B 9489
FLEXIBLE DISK DRIVE

TECHNICAL
MANUAL

PUBLICATION
CHANGE
NOTICE

PCN No.: 2102141-002 Date: January 1980
Publication Title: B 9489 Flexible Disk Drive Technical Manual
Other Affected Publications: None
Supersedes: None

FIGURE 1.

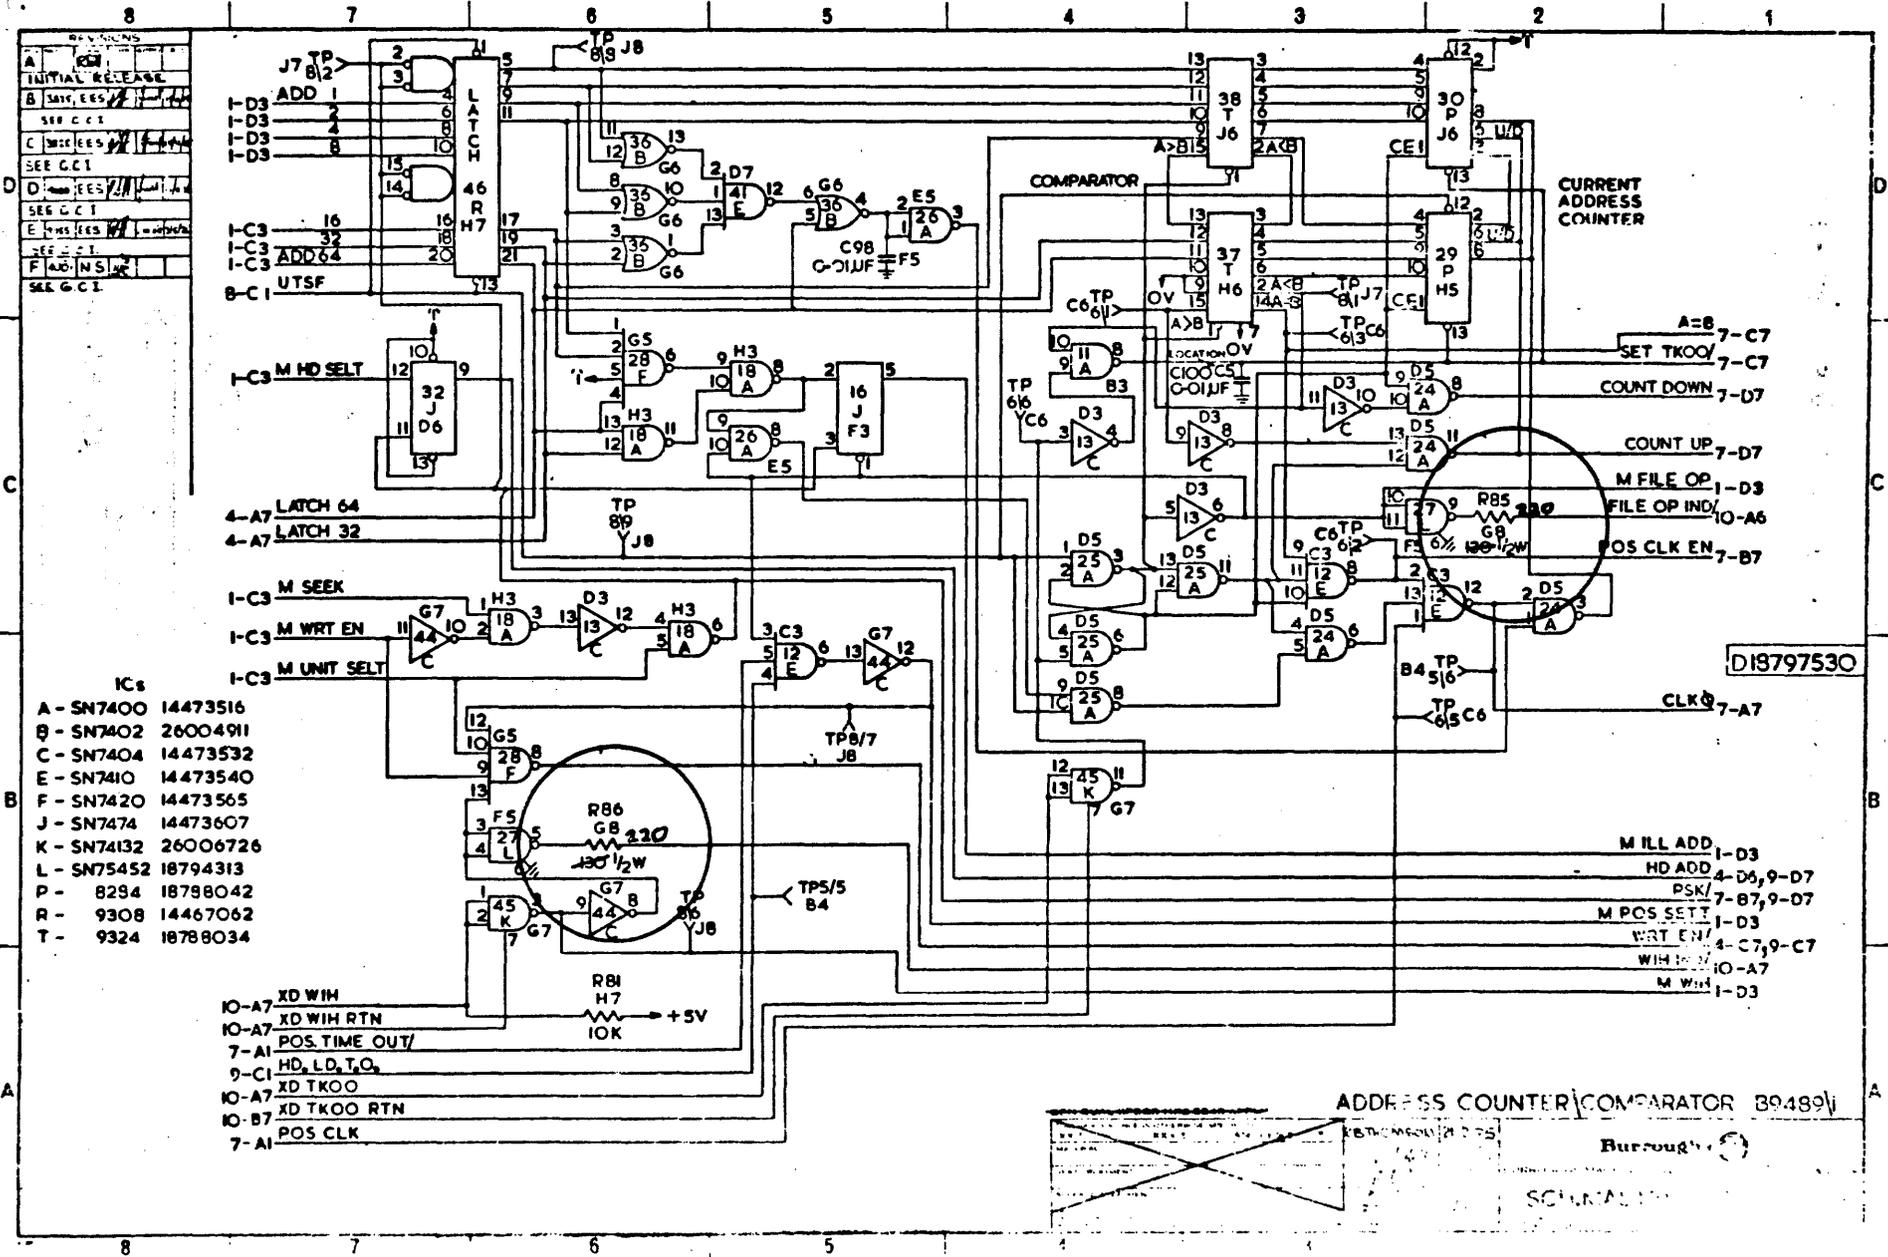
Update the schematic as shown in figure 1.

Figure 1. Removing Separator Clip from Sachet

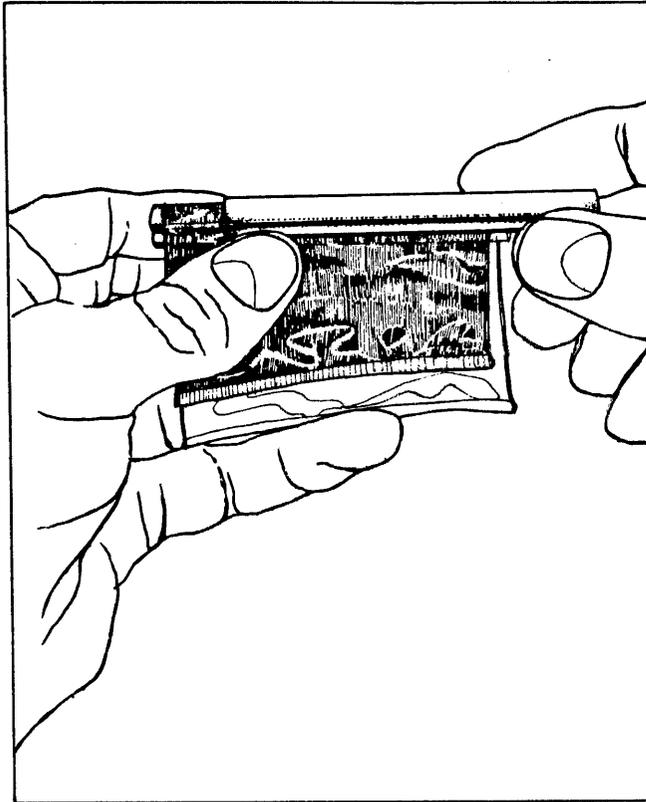
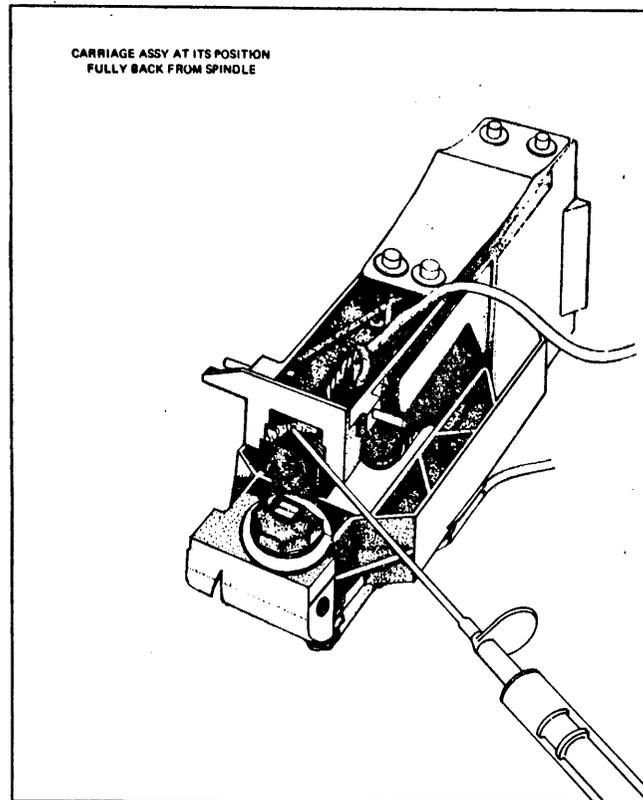
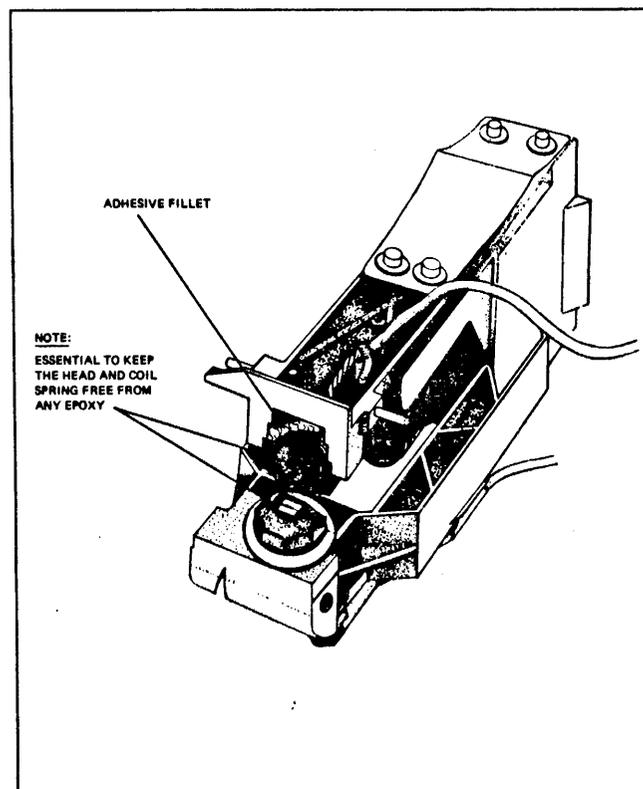
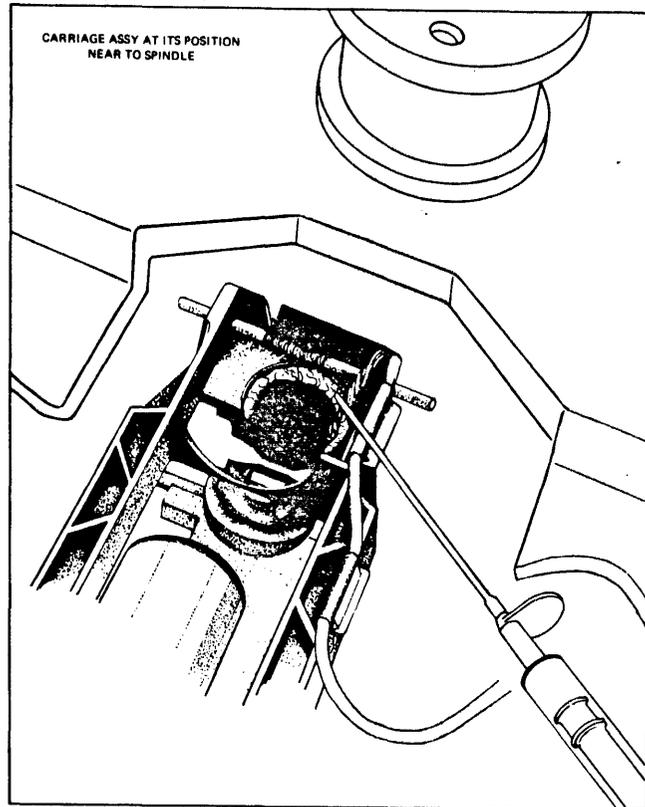
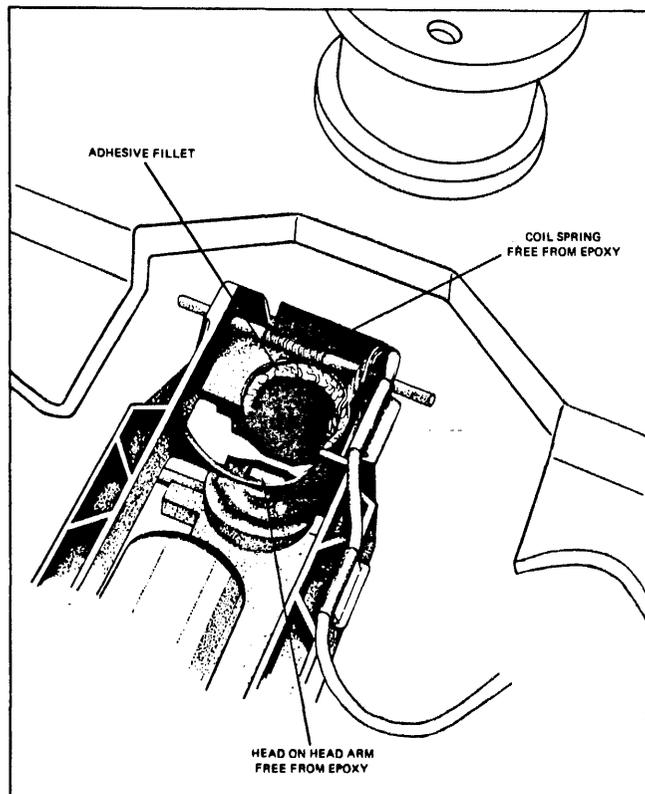
1. Remove minidisk drives from the B80.
2. Remove the metal cover and the printed circuit board from the minidisk drives.
3. The adhesive sachet has 2 compartments. One compartment contains the adhesive and the other the hardener. The adhesive and hardener are separated from each other by the plastic clip. See figure 1 for details.

10. Use the cleaning wad to remove any spots of adhesive from adjacent areas.
11. Turn the unit over, and repeat steps 8 thru 10 for the lower head.
12. Make a final inspection to ensure the adhesive has not contaminated adjacent surfaces.
13. Replace the metal cover and printed circuit board.
14. Follow steps 8 thru 13 for the other mini disk drive.
15. Re-install drives into the B80.
16. Power up the B80 and leave for at least 6 hours for the adhesive to harden. (This may conveniently be done overnight).

FIGURE 1

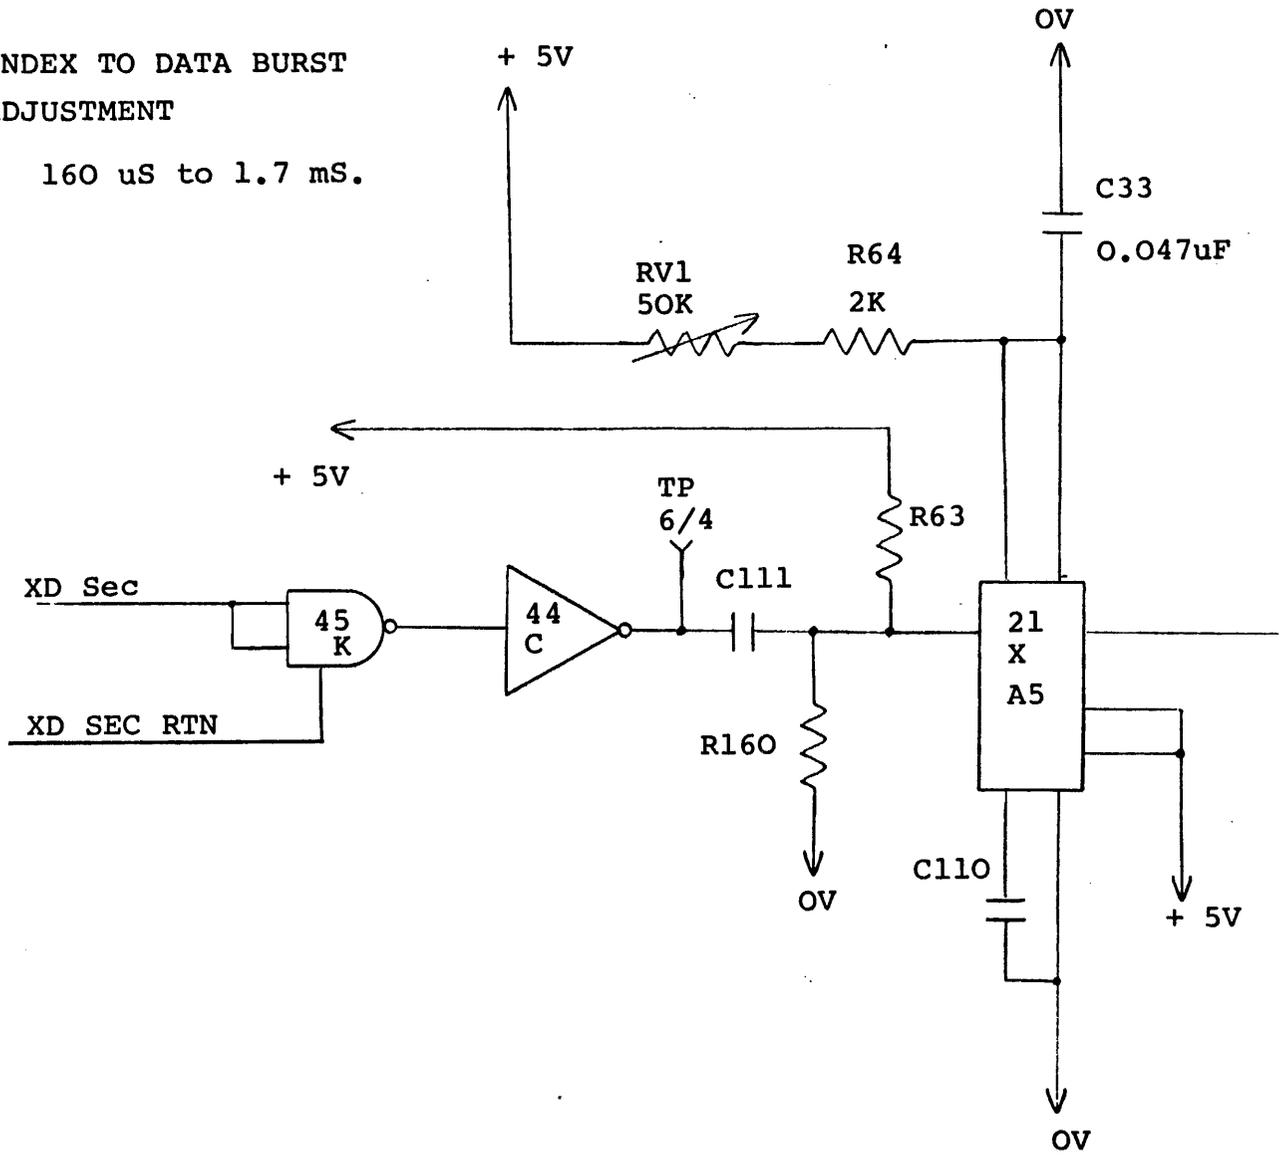
1. Switch off power to host system.
2. Remove disk drive from host system.
3. Remove revision K board from drive.
4. Replace potentiometer RV1 at location B 6 with a 50K pot.
5. Replace resistor R64 at location A5 with a 2K ohm resistor.
6. Replace capacitor C33 at location A5 with a 0.047uF capacitor.
7. Refit revision K board to drive.
8. Refit disk drive to host system.
9. Switch on Power to Host system.
10. Carry out circumferential alignment procedure.
11. Amend the schematic drawing to reflect change. (Refer to Figure 1)

FIGURE 1 : SHOWING THE POSITION OF THE CLAMPS.

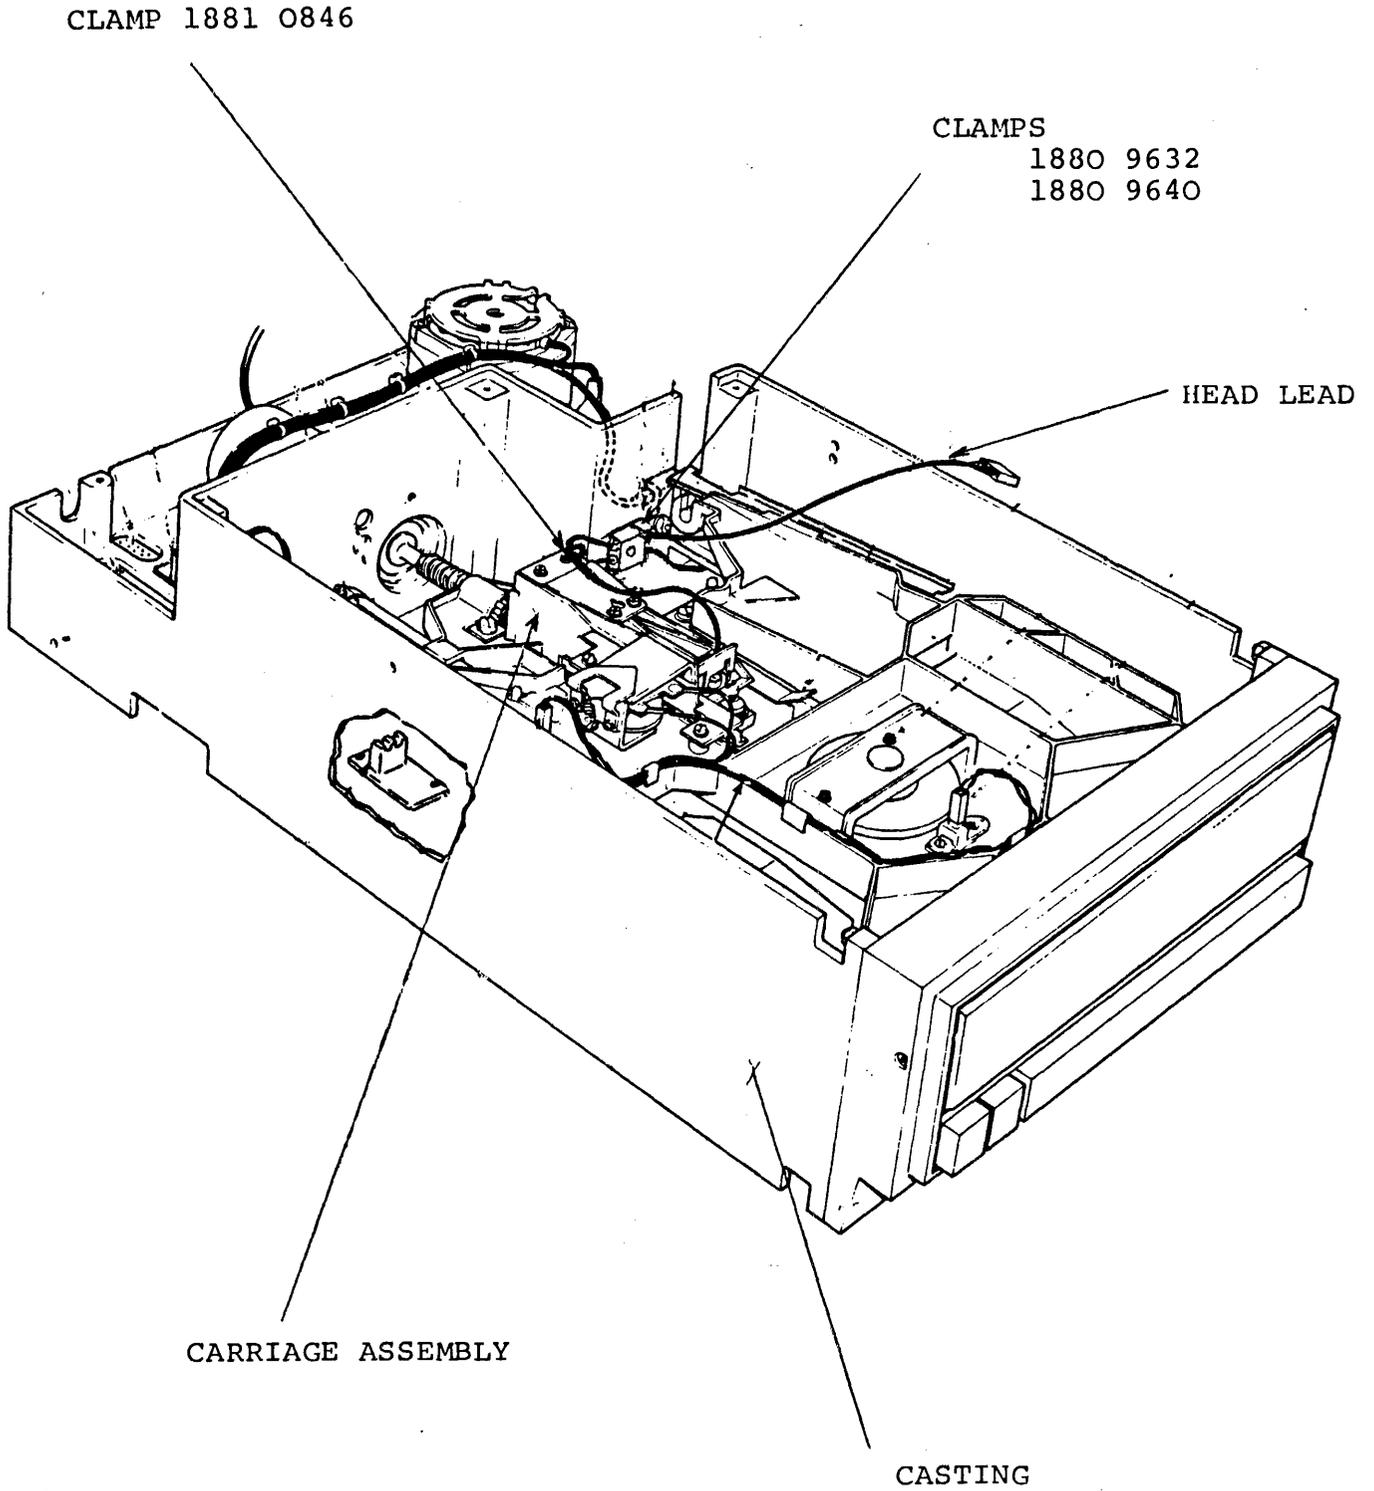
4. Remove clamps (P/N 1880 9632 & 1880 9640) that secure the head leads to the casting in the vicinity of the carriage assembly.
5. Refit the side panel of the Disk Drive unit.
6. Switch on the power to the Host System.
7. Carry out functional check of the System.

FIGURE 1 : CARTRIDGE RECEIVER AND ANNULUS ASSEMBLY.
Printed in U.S. America

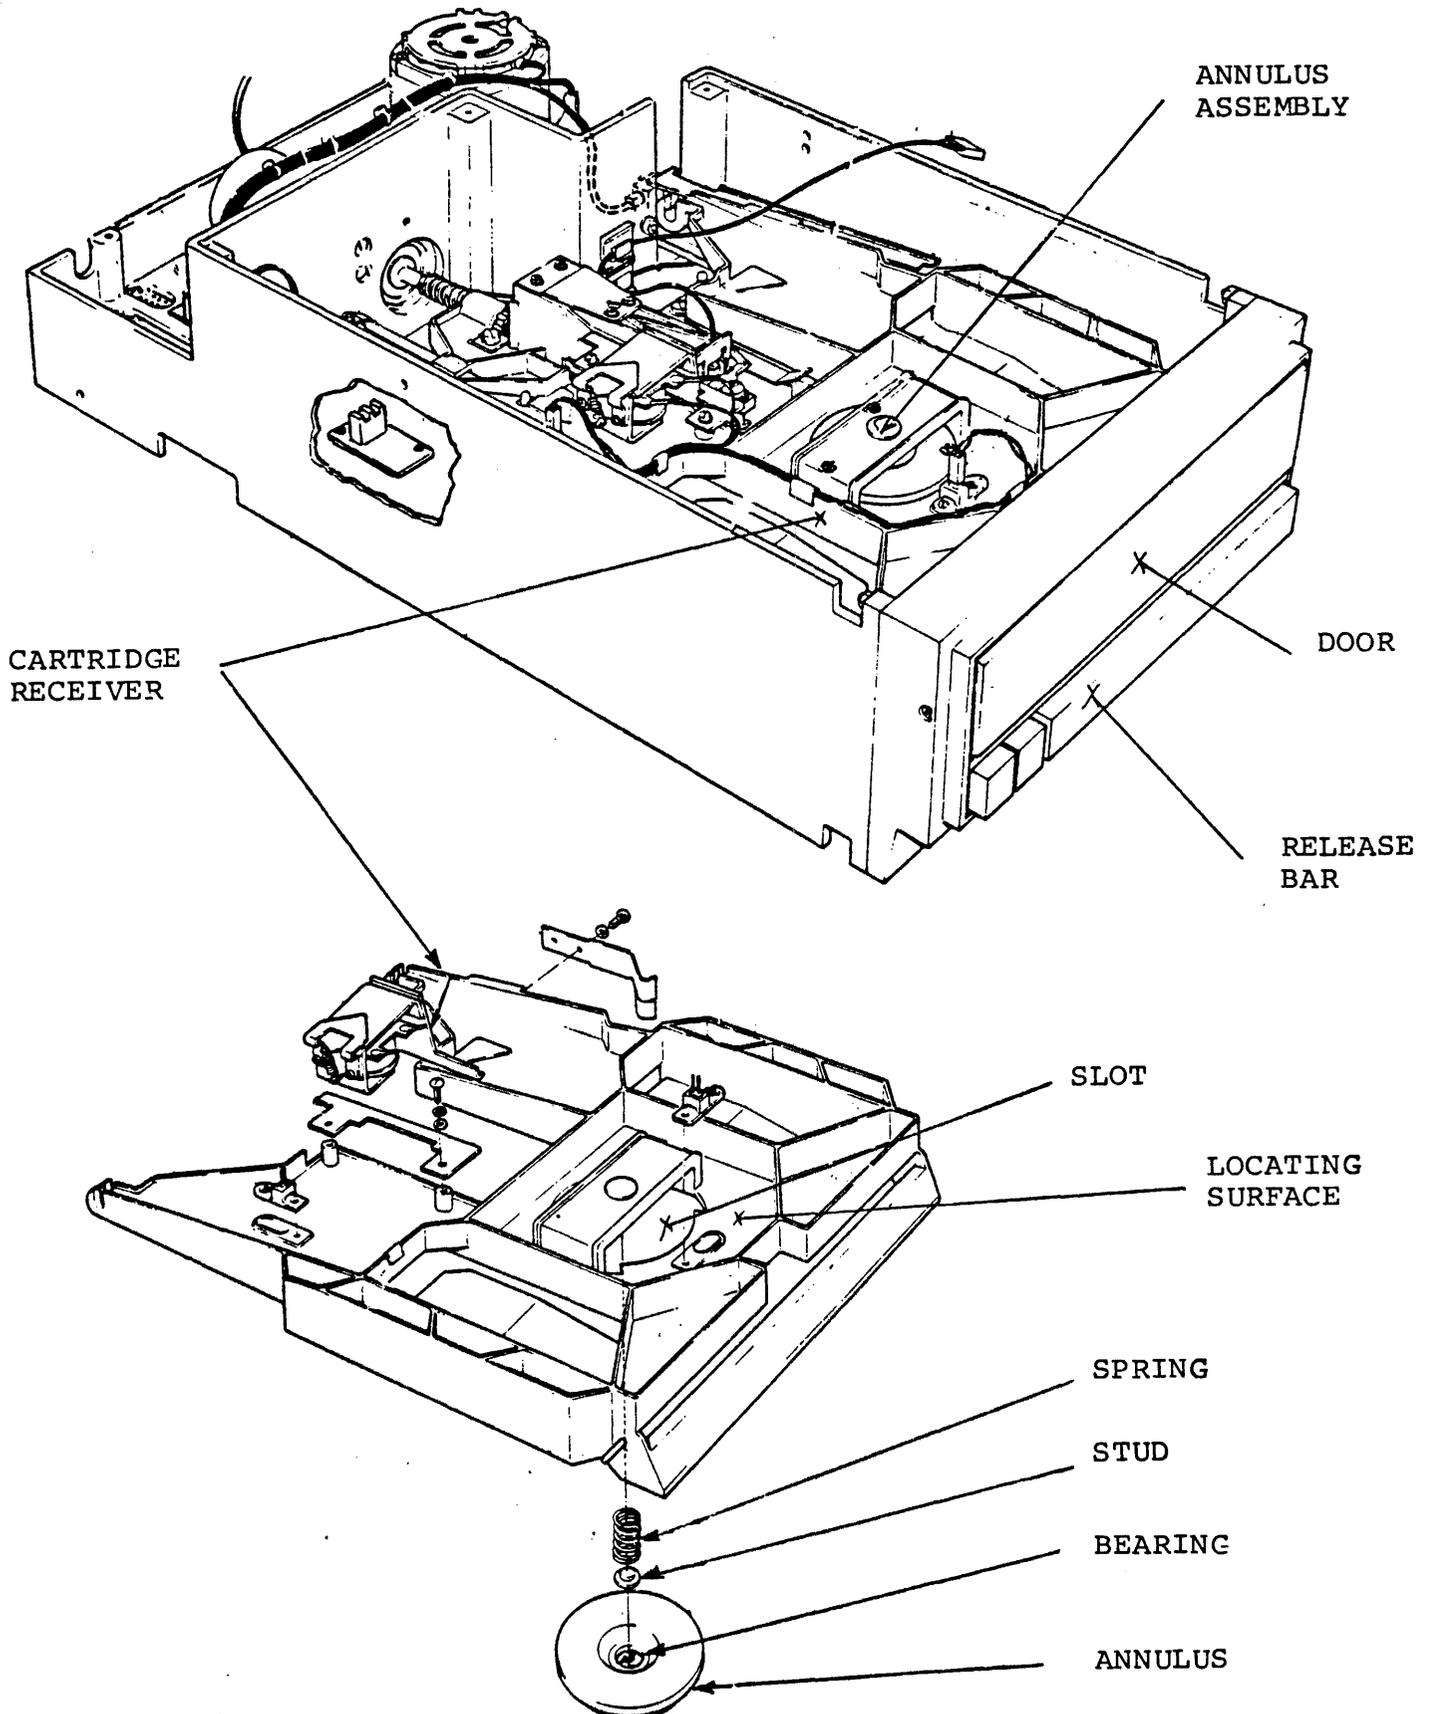
4. Set the annulus to an angle and move one side of the annulus below the cartridge receiver locating surface.
5. Remove the spring and stud. (See Figure 1)
